Comments on Potential Geologic and Seismic Hazards Affecting Proposed Liquefied Natural Gas Site in Santa Monica Bay, California

Open-File Report 2008-1344

Comments on Potential Geologic and Seismic Hazards Affecting Proposed Liquefied Natural Gas Site in Santa Monica Bay, California

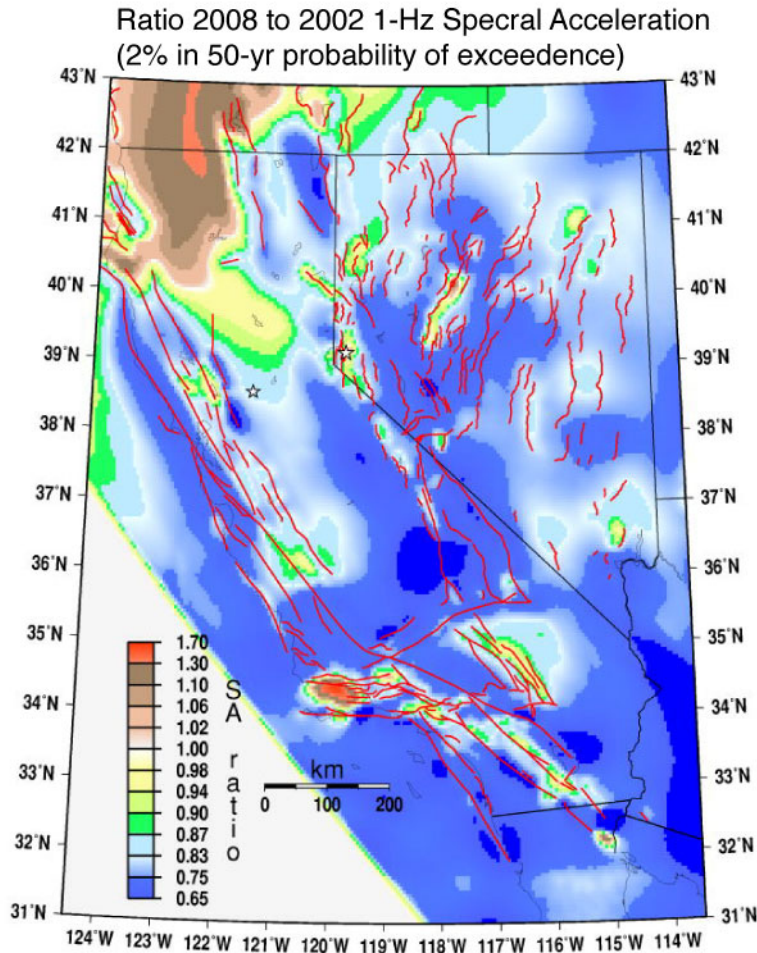
Significant updates to the earthquake hazard assessment in California have been published during 2008, including a new version of the USGS National Seismic Hazard Mapping Project (NSHMP, 2008) maps and a new earthquake probability forecast known as the Uniform California Earthquake Rupture Forecast version 2 (UCERF2) from the Working Group on California Earthquake Probabilities (WGCEP, 2008). The new NSHMP mapping combines the UCERF2 earthquake probabilities with new models of how much shaking is produced by earthquakes. These new shaking models are known as the Next Generation Attenuation (NGA) relations. These changes have some significant effects on hazard assessment including: (1) there is often increased motion on the hanging wall of reverse and normal faults, and (2) intermediate- to long-period median

ground motion estimates are reduced compared to previous models (~25% near some of the major faults such as the San Andreas). Figure 2 highlights some of these effects, expressed as a ratio between the 2008 and 2002 NSHMP estimates.

We recommend that the hazard assessment provided in the Geological Resources document be compared for consistency with the NSHMP 2008 results. Ideally a ratio grid for the regions of interest similar to that of figure 2 would be produced. Further, because the Whittier-Elsinore and San Andreas Faults are discussed in the Geological Resources

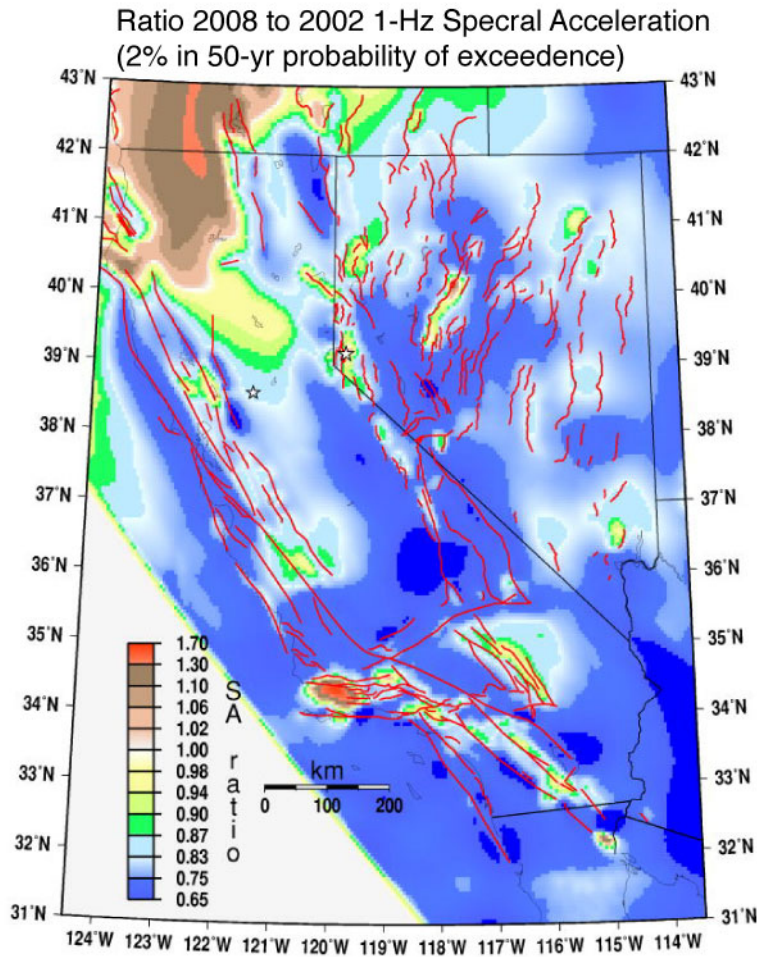
My main comment is that significant updates to the earthquake hazard assessment in California have come on line during 2007-2008, including a new version of the USGS National Seismic Hazard Mapping Project (NSHMP, 2008) maps and a new earthquake probability forecast from the Working Group on California Earthquake Probabilities (WGCEP, 2008). The NSHMP mapping uses the Next Generation Attenuation (NGA) models which have the following updates: (1) the use of VS30 for the site condition, inclusion of a depth of rupture factor, (2) inclusion of hanging wall factors, and (3) inclusion of depth of soil factors. All of the models include non-linear site response effects. Three of the models include the effects of the soil non-linearity on the standard deviation. These changes have some significant effects on hazard assessment including: (1) there is often increased motion, even for 1s spectral acceleration, over the hanging wall of reverse and normal faults, and (2) intermediate to long period median ground motion estimates are reduced compared to previous models (about 25% near some of the major faults such as the San Andreas). The attached figure 2 highlights some of these effects expressed as a ratio between the 2008 and 2002 NSHMP estimates.

A recommendation is that the hazard assessment provided by Fugro West, Inc., be compared for consistency with the NSHMP 2008 results. Ideally a difference grid for the regions of interest similar to that of figure 2 would be produced. Further, since the Whittier-Elsinore, and San Andreas Faults are discussed, the WGCEP (2007) updated time dependent probabilities for those faults should be considered.

Figure 4. Deaggregation for the Santa Monica site using the USGS (Petersen and others, 2008) model.

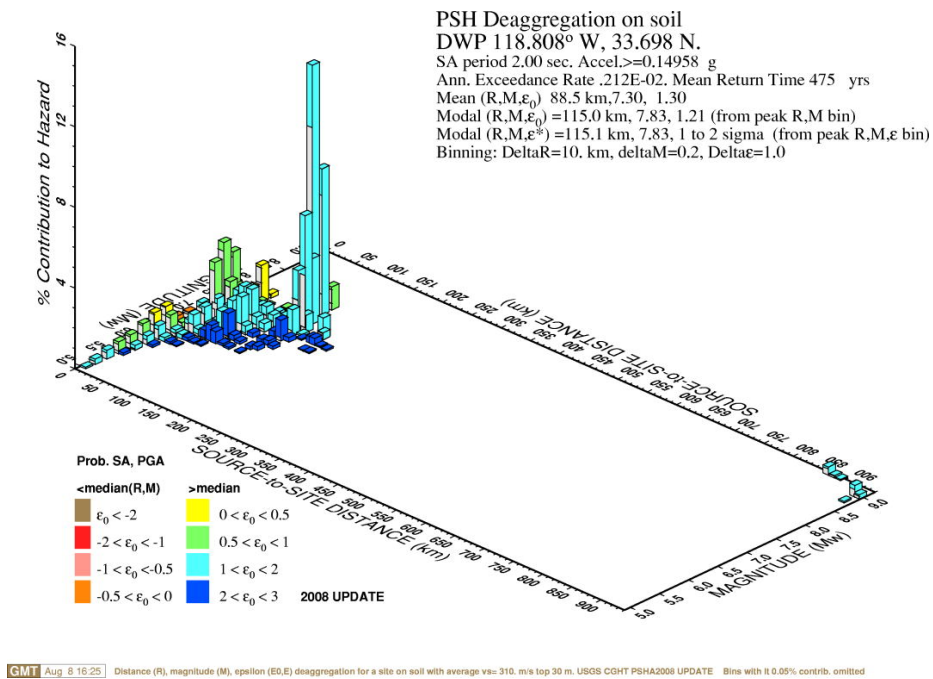
6. Deaggregation plots generated by the USGS contain contributions from the San Andreas Fault whereas the deaggregation plots in the report do not show these contributions from distant sources (see fig. 4).
